Removal of solar panels south of Oxford Airport

Appendix 2: Change 2

Title: Change Request 2 Notification - Change 2

Appendix 2 - Change 2

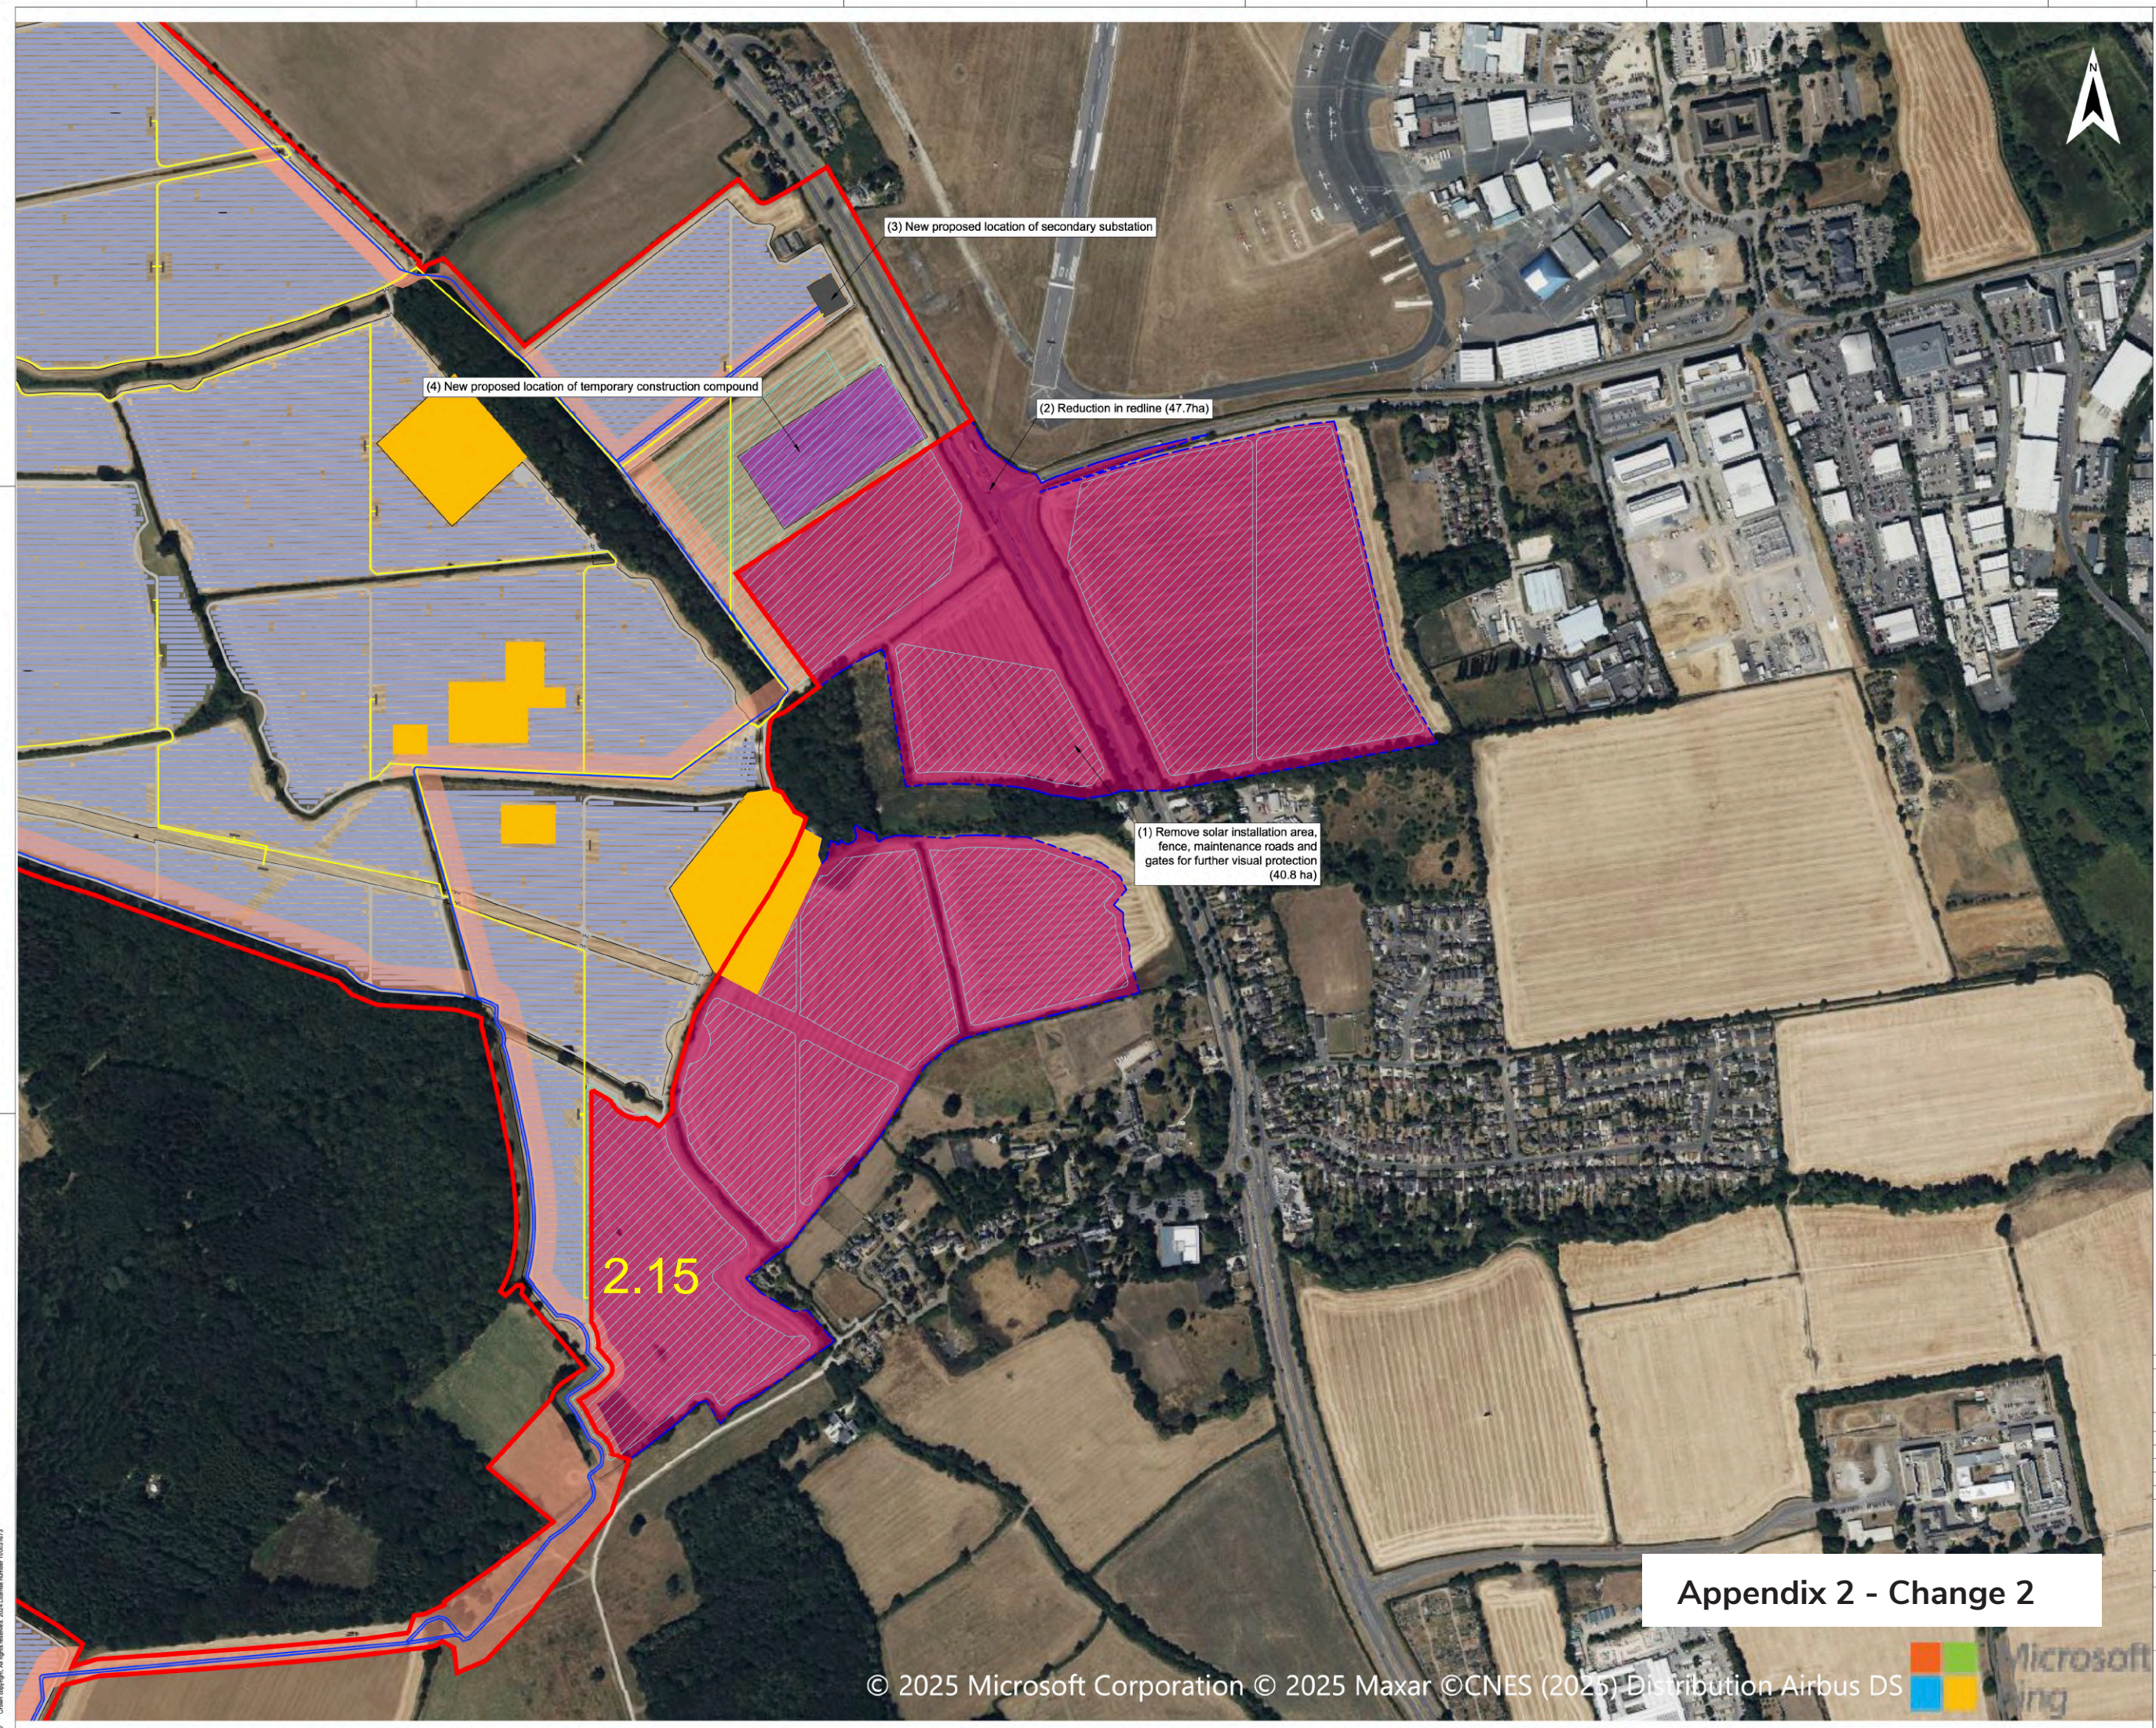
Appendix 2- change 2 is the missing map of the proposed changes and I have appended it below and have marked field 2.15 on the map.

There seems to be a completely unnecessary narrow strip of solar panels on the western edge of field 2.15 next to Bladon Heath Wood. This would destroy the view of the field and wood from Springhill Road and from the bridleway. and would reduce a section of this bridleway to a corridor between the hedge and the high fencing around the small slice of solar farm.

Planning to put solar panels and cables so close to the wood flies in the face of the advice of the Forestry Commission. They recommend a large buffer zone, to protect the trees and creatures of the woodland edge. They also stress the importance of connectivity between areas of woodland. Field 2.15 is a link between Bladon Heath Wood and Begbroke Wood and beyond. Solar panels and their fencing would badly damage this pathway.

Please insist that PDVP remove solar panels completely from field 2.15!
